Re: URBAN DESIGN SUBMITTAL
Capitol West SIP – Major Alteration
FINAL APPROVAL APPLICATION

Project: Capitol West – Phase I: **Alteration to the SIP**
Block 51, bounded by West Washington Avenue, South Henry Street, West Main Street and Broom Street

Five Conditions of Initial Approval

HENRY ST. PLANTING REVISION - BENCH ADDITION

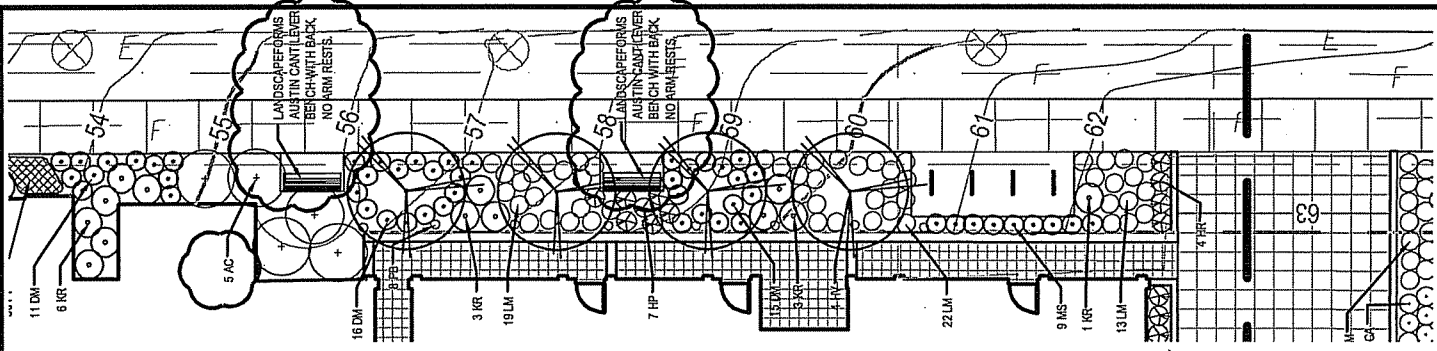
- 1) Add bike racks at mews. We have added two additional bike racks at the entrance to the Mews along Henry Street for a total of 28 Visitor Bike Parking Stalls on site. These added bike racks can be seen on Sheet 2 attached.
- 2) Add Public Seating at Henry Street. We have provided two benches for public seating along Henry Street at grade. The location of these benches can be seen on Sheet 1, and the specification is attached as well.
- 3) Increase caliper/height of plantings along Henry Street landscape bed. The sizes of the initial plantings along Henry Street, at the landscape bed adjacent to the building, have been increased. The type and size of plantings can be seen on Sheet 1 attached.

MEWS CABLE TRELLIS & ADDITIONAL BIKE RACKS ON HENRY ST.

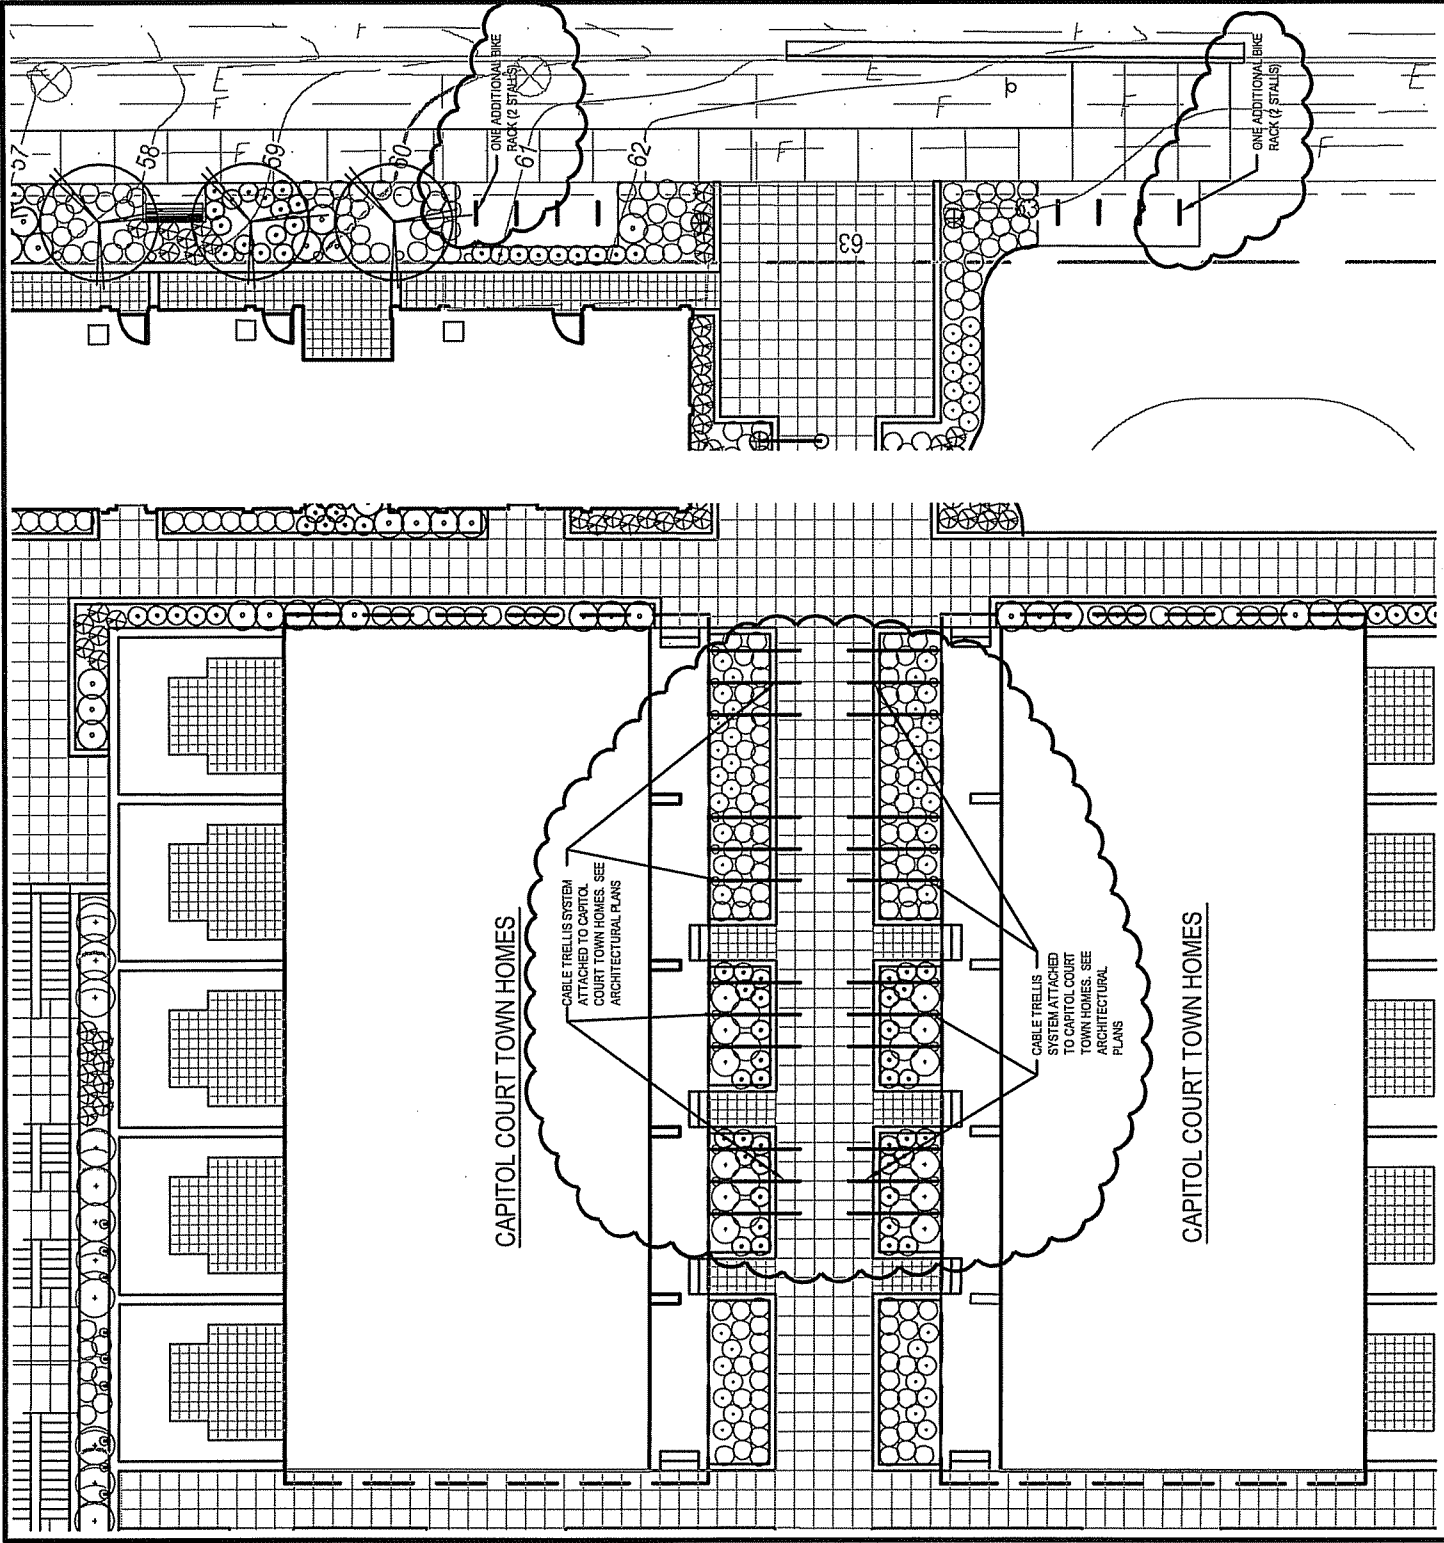
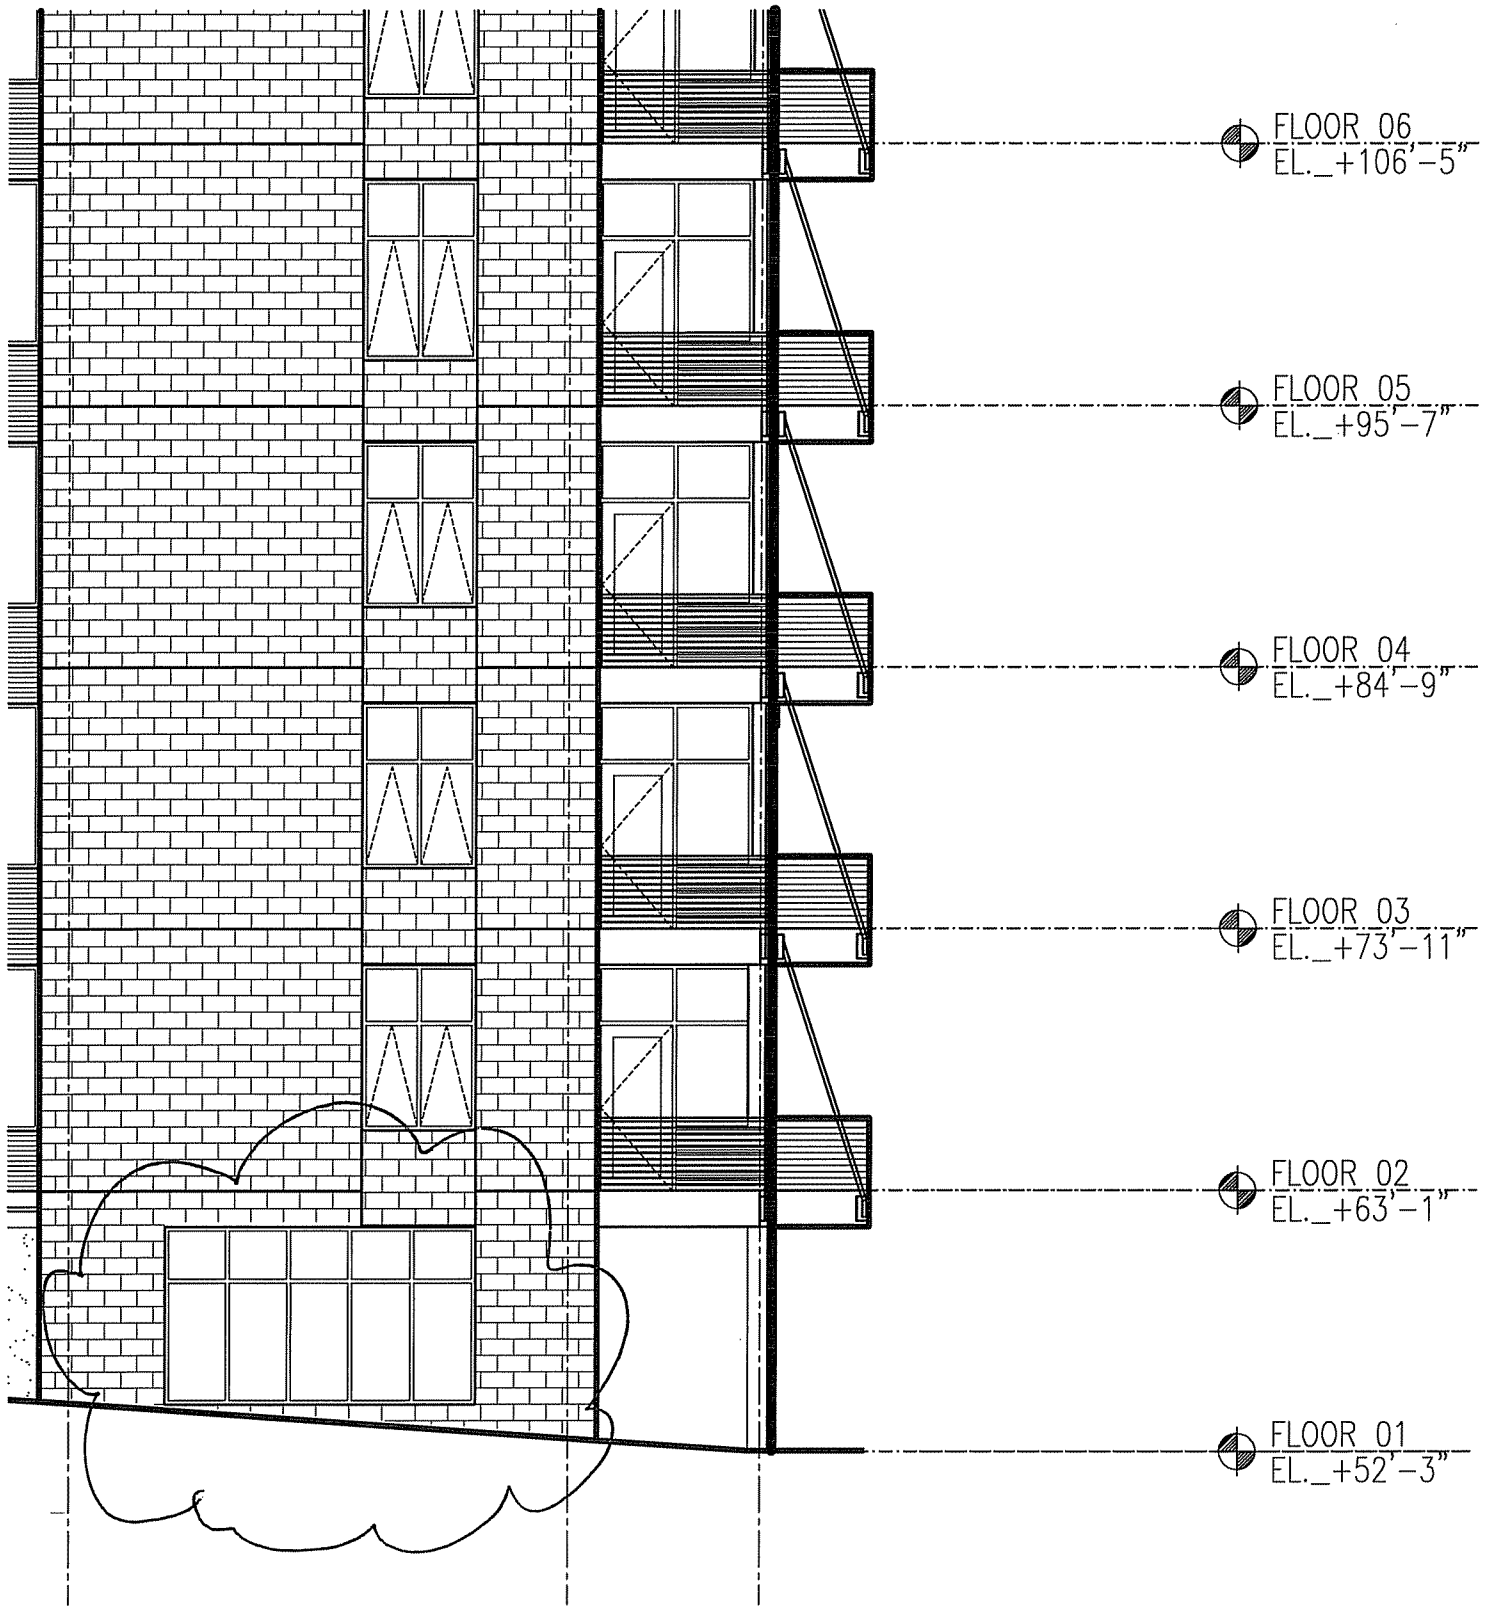
- 4) Add back 4 of 5 overhead trellises at Capitol Court Townhomes. We have added back 4 of the original 5 overhead trellises across the mews at the location of the Capitol Court Townhomes. These can be seen on Sheet 2.
- 5) Add storefront glazing in north face of East Masonry Tower. Storefront glazing has been included in the Eastern Masonry Tower at the first floor retail. This glazing, in the north face of the Tower, can be seen in Sheet 4.
